## PIC16CR62 Rev. A Silicon Errata Sheet

The PIC16CR62 (Rev. A) parts you have received conform functionally to the Device Data Sheet (DS30234D), except for the anomalies described below.

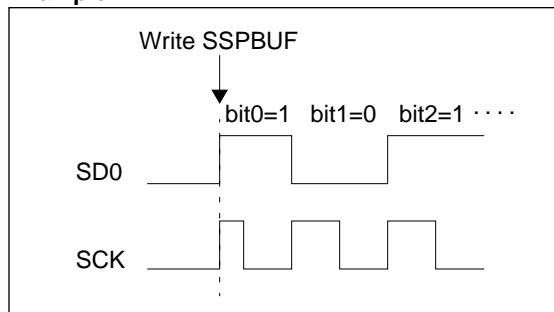
When the SPI is using Timer2/2 as the clock source, a shorter-than-expected SCK pulse may occur on the first bit of the transmitted/received data.

To avoid producing the short pulse, turn off Timer2 and clear the TMR2 register, load the SSPBUF with the data to transmit, and then turn Timer2 back on.

**FIGURE 1: WRITES TO TIMER1 (EXTERNAL CLOCK / OSCILLATOR MODE)**

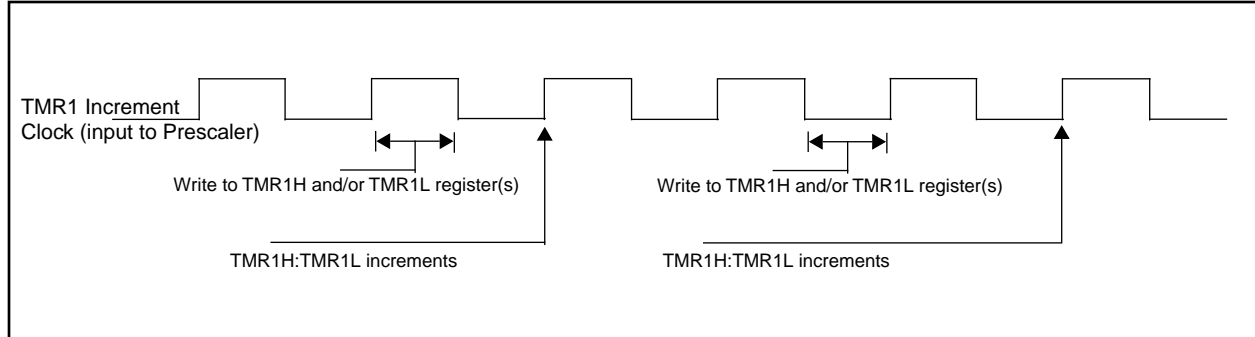
- a) The operation of Timer1 needs some clarification when the timer registers are written when the TMR1ON bit is set.
- The internal clock signal that is the input to the TMR1 prescaler affects the incrementing of Timer1 (TMR1H:TMR1L registers and the Timer1 prescaler). When the Timer1 registers are NOT written, the Timer1 will increment on the rising edge of the TMR1 increment clock.

When the TMR1H and/or TMR1L registers are written while this clock is high, TMR1 will increment on the next rising edge of this clock.

When the TMR1H and/or TMR1L registers are written while this clock is low, TMR1 will not increment on the next rising edge of this clock, but must first have a falling clock and the the rising clock for TMR1 to increment.

Figure 1 shows the two cases of writes to the TMR1H and/or TMR1L registers. Due to the  $V_{IH}$  and  $V_{IL}$  thresholds on the oscillator/clock pins, external

Timer1 oscillator components, and external clock frequency, the Timer1 increment clock may not be of a 50% duty cycle.

The TMR1 increment clock is out of phase of the T1OSO/T1CKI pin by a small propagation delay.
